Addendum 01

DOCUMENT 00 9100

PROJECT: Fairbanks Local Schools - Access Drive
11158 OH-38
Milford Center, Ohio 43045

PROJECT #: 24045.02

PROJECT MANAGER: [Blank]
ENGINEER: [Blank]
PROFESSIONAL STAMP: [Blank]
ISSUANCES / REVISIONS: [Table with columns: NO., DATE, DESCRIPTION, BID DOCUMENTS, ADDENDUM 01]
SHEET NAME: [Blank]
DATE: 03/24/2026
DRAWN BY: CAW
SHEET: **C2.2**
ROAD GRADING PLAN
GM JOB # 26010

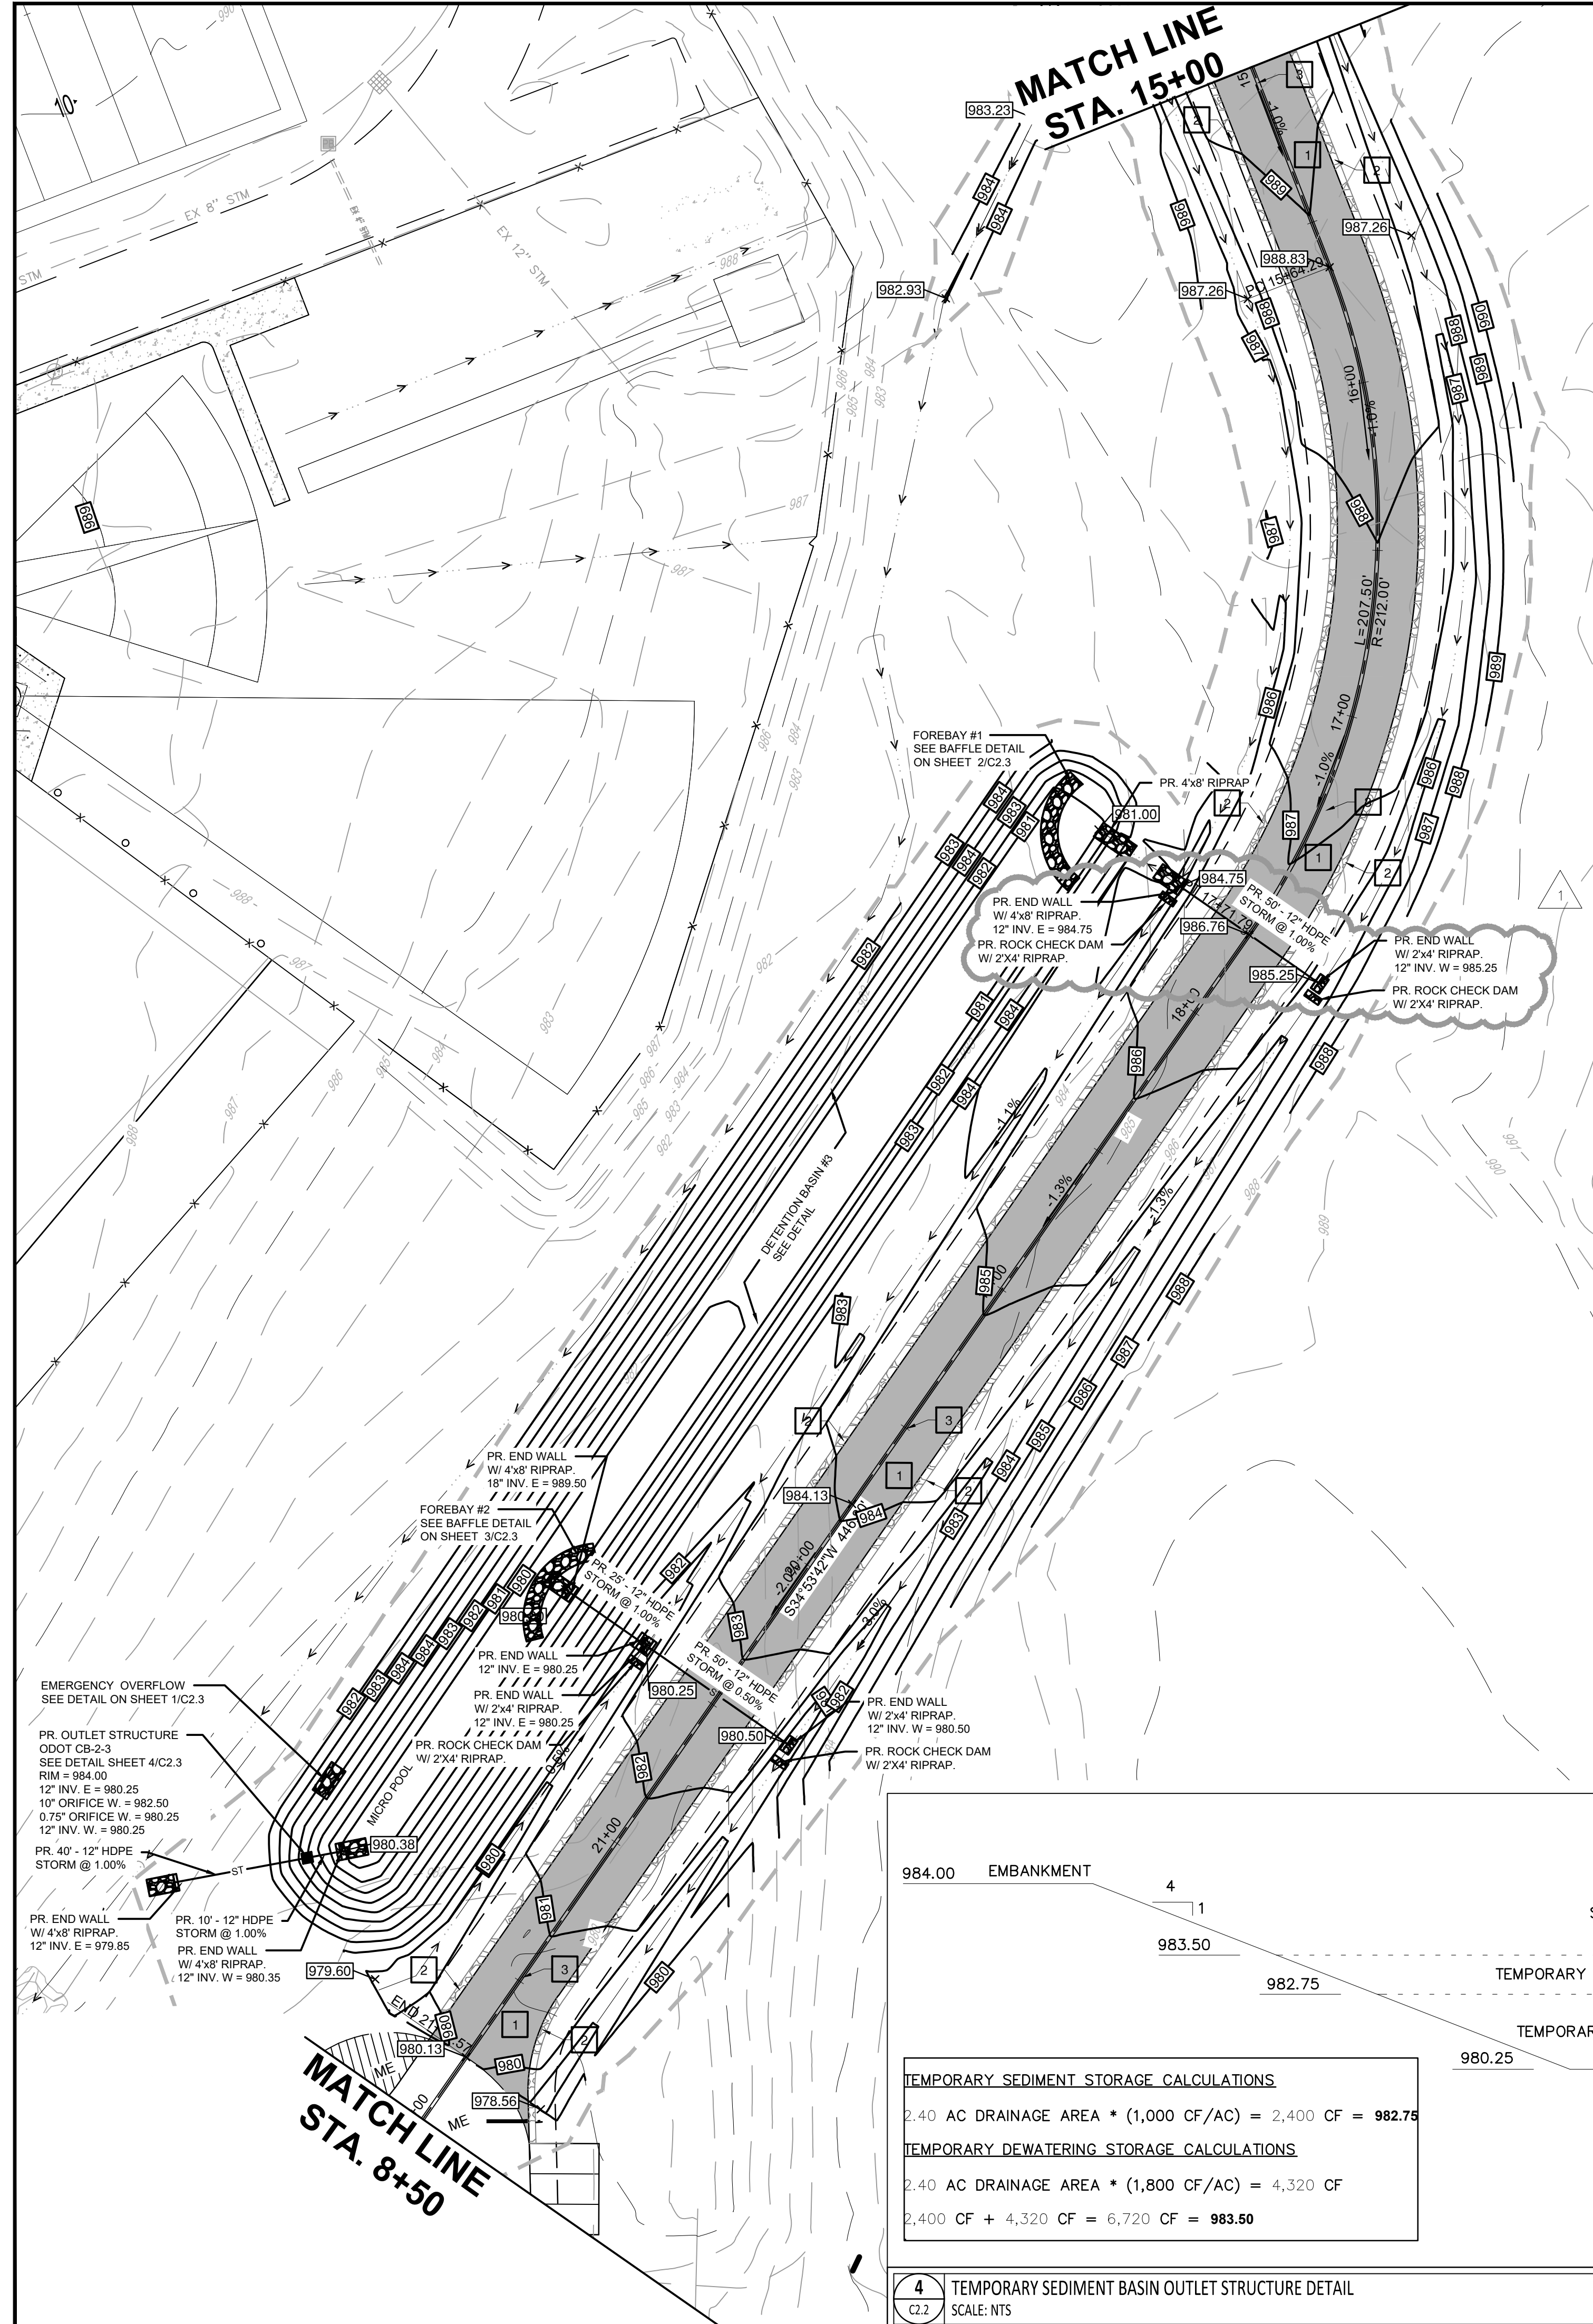
1. Drawing Sheet C2.2: Road Grading Plan –
 - a. Added missing label on storm pipe crossing road.
2. Drawing Sheet C2.3: Road Grading Plan –
 - a. Added missing label on storm pipe crossing road.
3. Drawing Sheet C2.4: Drop Off Site Plan –
 - a. Added keyed note tag for Lane Delineators.
 - b. Added Accessible Ramp and keyed note 18.
 - c. Added keyed note for location of rolled curb.
 - d. Added keyed note 10.
4. Drawing Sheet C4.0: Site Details –
 - a. Revised Detail #5 Typical Section for the lane widths to 12' lanes and 24' overall.
 - b. Revise Detail #7, Notes and added Staff Parking for location.
 - c. Revised Detail #8 with correct number and label for 6" Vertical Curb.
 - d. Added Detail #9 for Accessible Curb Ramp Detail.

5 ROAD TYPICAL SECTION
SCALE: NTS

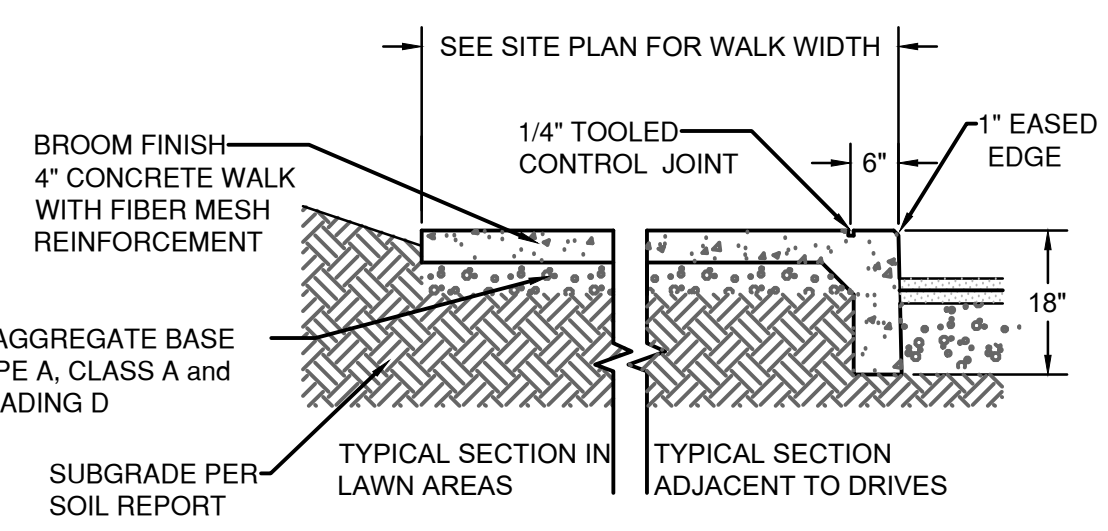
1. Sealcoat Areas. 1 Coat or 2 Coats? Any Specs on sealcoat?
 1. **1 Coat of sealcoat.**
2. Asphalt Paving Details on Page C4.0. There are 2 details for asphalt paving profiles and the thickness are different. Also 1 specifies a certain asphalt and the other does. Is it Possible to choose one profile thickness for both areas and same asphalt spec?
 1. **Detail #5 is for the road and Detail #7 is for the parking lot.**

3. Road Typical Section. On Page C4.0, Detail 5. Road Typical Section. It calls for the lane width to be 24ft wide for total roadway width of 48ft wide. Is this correct?
 1. **12' lanes or 24' overall.**
4. On page 7, what are the limits of the 4" roll over curb?
 1. **Roll curb is on the radius area. We have labeled it on Addendum #1.**
5. If site is short on dirt, will we be allowed to dig a borrow pit on site?
 1. **If additional fill is required, it can be obtained from on-site stockpiles or other on-site location to be determined.**
